Docket Number:	02-AFC-01C
Project Title:	Sonoran Energy Project (formerly Blythe Energy Project Phase II) - Compliance
TN #:	206331
Document Title:	Data Requests Set No. 1 (1-58)
Description:	Sonoran Energy Project - Data Requests Set No. 1 (1-58) 10-12-2015
Filer:	Mary Dyas
Organization:	California Energy Commission
Submitter Role:	Commission Staff
Submission Date:	10/12/2015 2:47:06 PM
Docketed Date:	10/12/2015

**Subject: SONORAN ENERGY PROJECT (02-AFC-1C) - PETITION TO AMEND
DATA REQUESTS - SET 1 (Nos. 1-58)**

SONORAN ENERGY PROJECT (02-AFC-1C)
DATA REQUESTS – SET NO. 1

SOIL & WATER TABLE 1: Water Budget for the Palo Verde Mesa Groundwater Basin

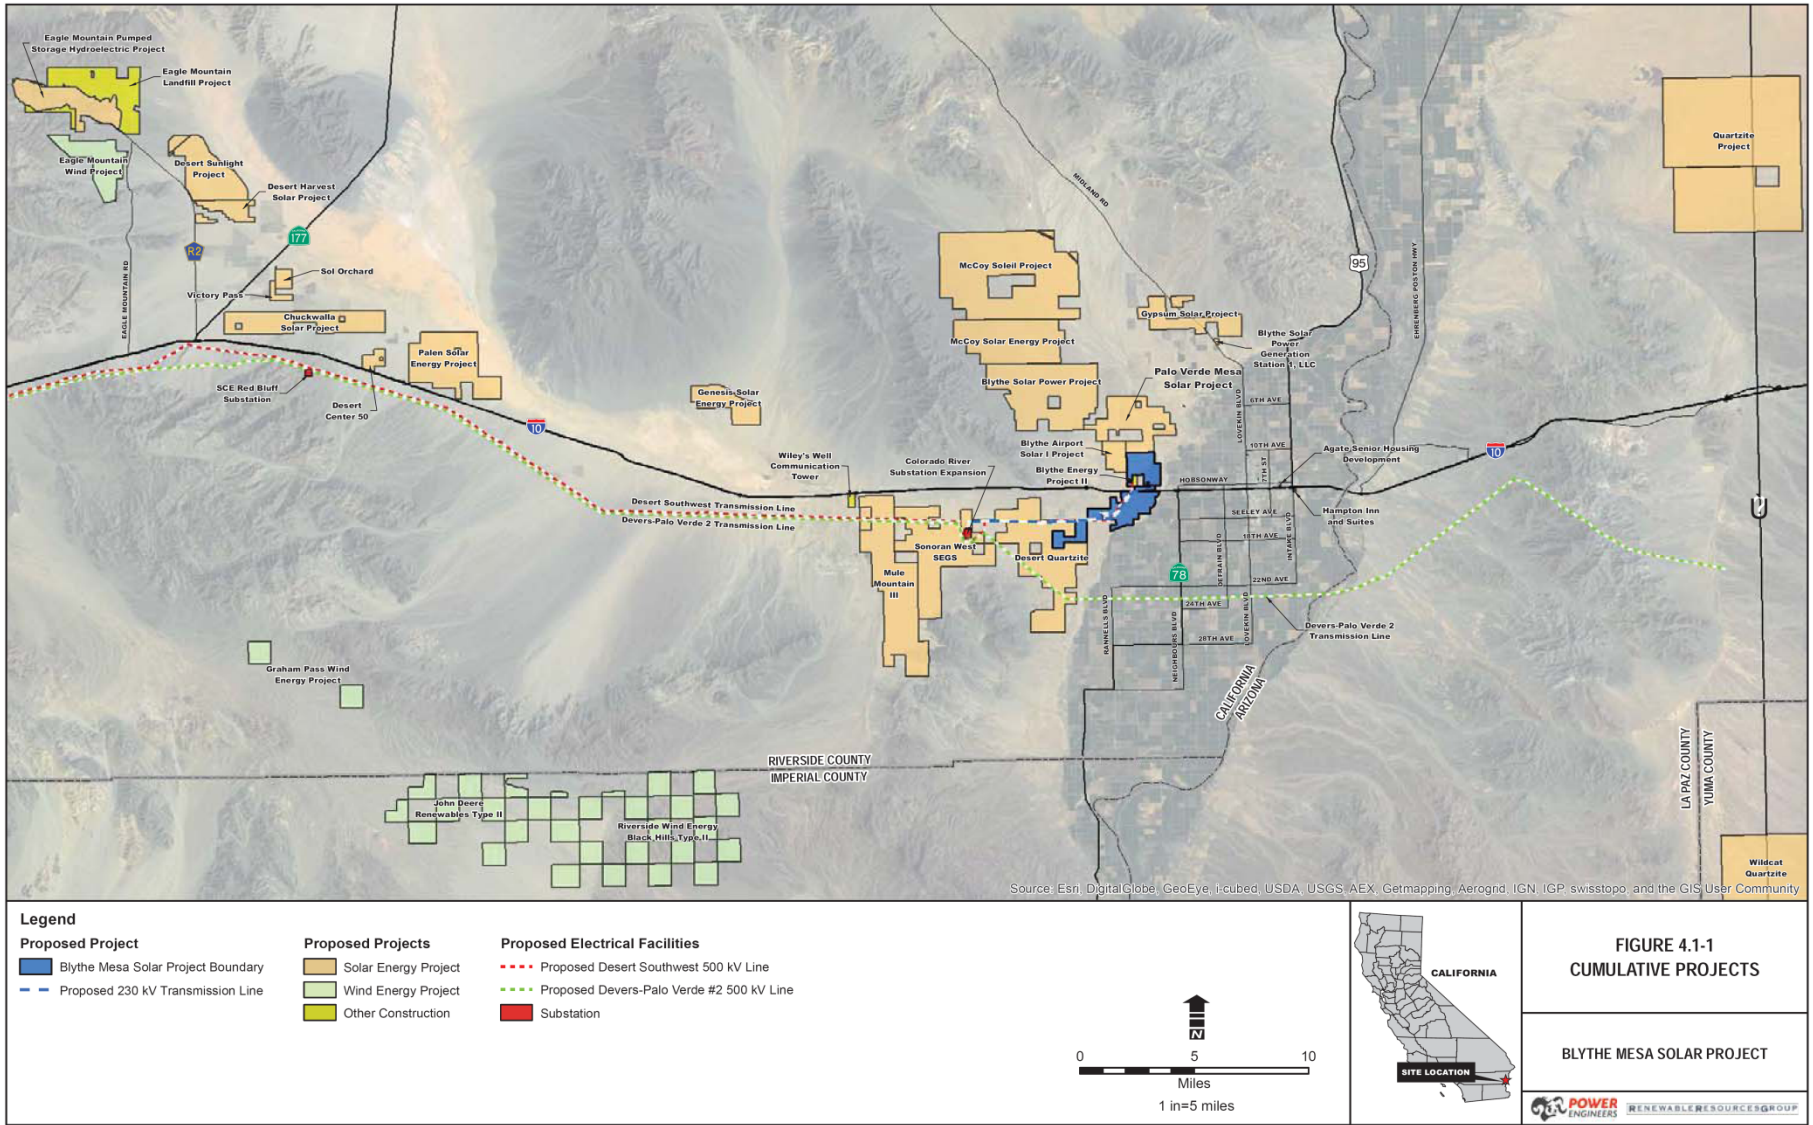
A groundwater basin budget was prepared for the Blythe Mesa Solar Project, which was licensed by BLM in 2015. The budget (include as Table 1 below) shows that the Palo Verde Mesa, not including water use at the Sonoran (or Blythe 2) project, is currently over-allocated by 2,111 acre-feet per year (AFY). Sonoran's proposed use would result in an over allocation of 4,911 AFY. There are also many other projects proposed or already in operation on the Palo Verde Mesa that could impact the budget in the future. A map of the potential projects is included below (BLM Figure 4.1-1 Cumulative Projects).

34. Please provide expected water use rate and source for the proposed AltaGas, LLC Irish Energy Project.
